RE: DRURY INN @ 25 DEVELOPMENT (F-17/D82)
(4310 The 25 Way NE)
ENGINEERS CERTIFICATION FOR CERTIFICATE OF OCCUPANCY
ENGINEERS STAMP DATED 11/8/2001
ENGINEERS CERTIFICATION DATED 5/29/2003

Re: Drury Inn (Tract J-1-A, The 25 Development) Grading & Drainage Plan, Engineer's stamp dated 11-08-01 (F17/D82)

DRAINAGE REPORT

Drury Inn Tract J-1-A, The 25 Development Albuquerque, New Mexico

Pipe Capacity

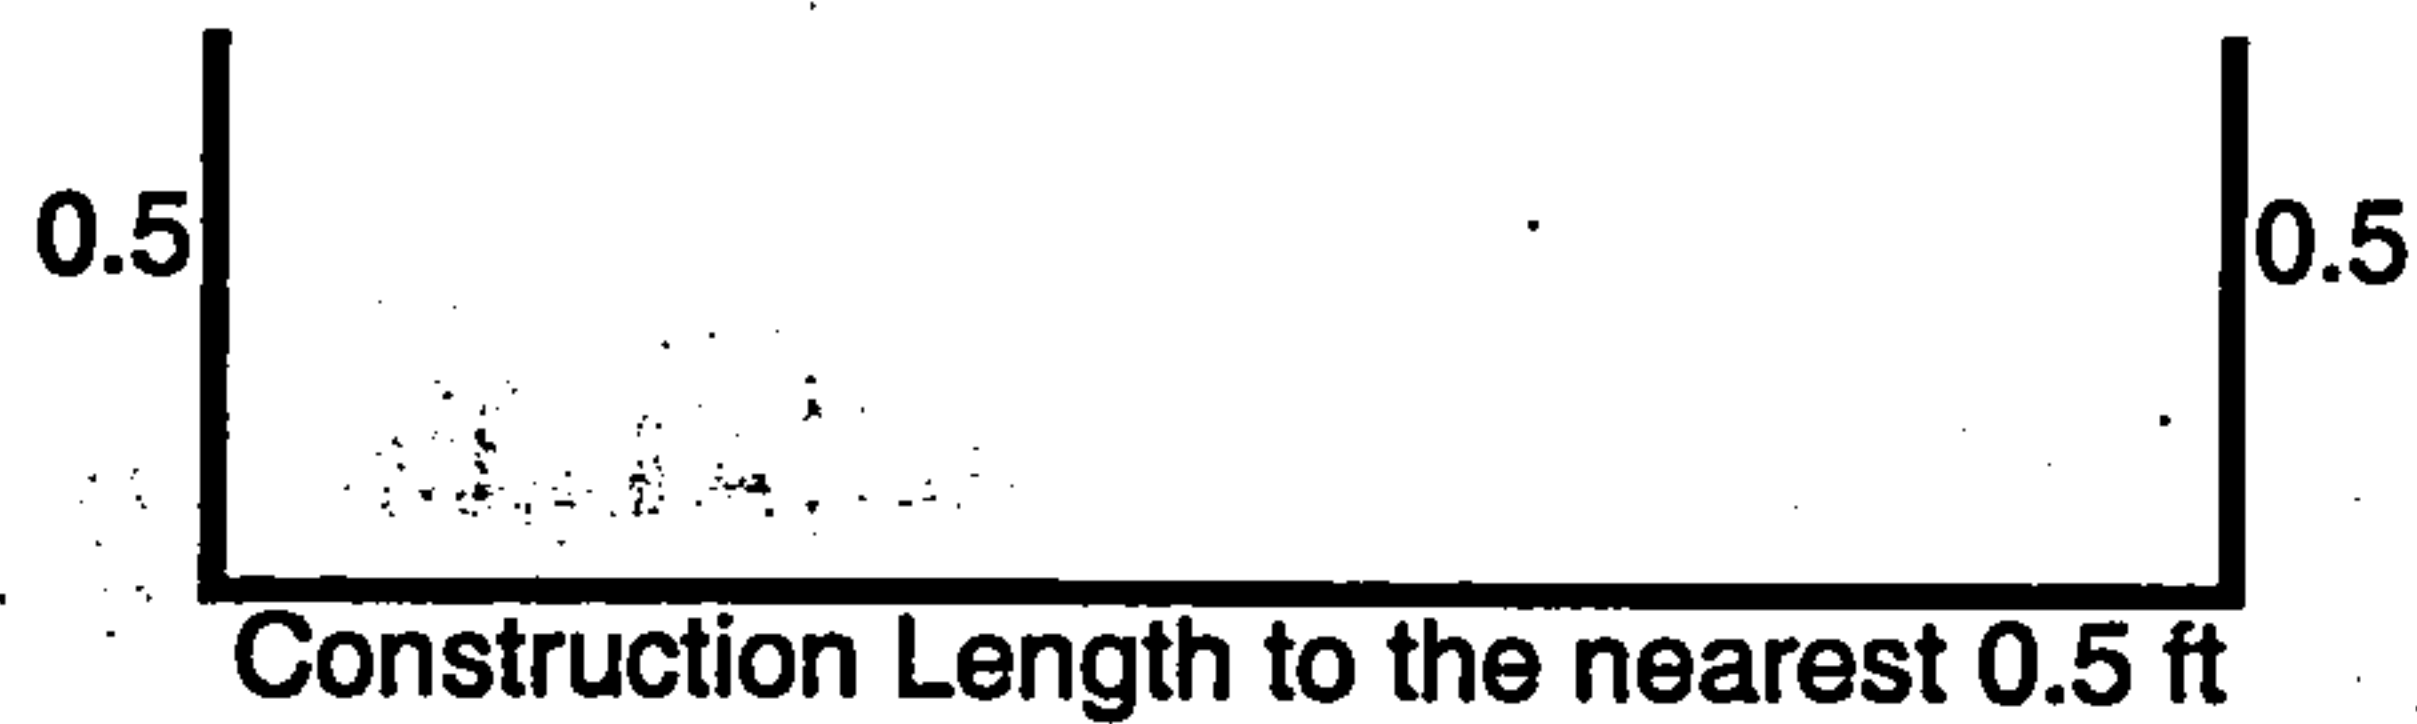
calculated

1.91
in previous
table
OK

These are 10" PVC's
